VERIFICATION REPORT OF THE 65MW DAGUSHAN HYDROPOWER PROJECT IN CHINA

Report No: VCS 023, rev. 02

Date of first issue: 2011-06-30	Project No.: VCS 023
Approved by: Markus Weber	Organizational unit: Greenhouse Gas Services
Client: Gansu Zhangye Dagushan Hydropower Co., Ltd.	Client ref. Mr. Jianjun Ding

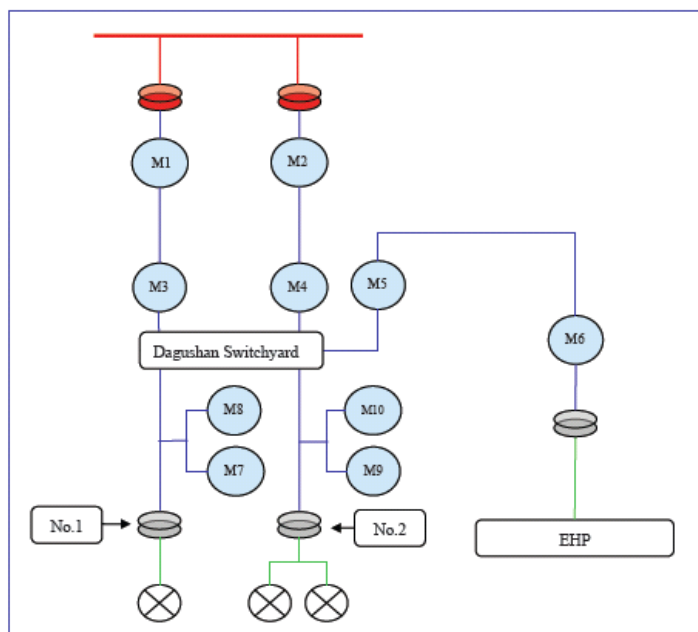
It is found many inconsistencies (e.g. accuracy & location of metering equipments, formulae of net electricity calculation) of monitoring report against description in registered PDD during on-site visit; hence, the revision of monitoring plan is requested in CAR 5.

The monitoring plan has been revised and approved by EB on 2011-03-03 (<http://cdm.unfccc.int/Projects/DB/RWTUV1256040897.46/view>), the monitoring report version 02 ^{/6/} was prepared as per the revised monitoring plan.
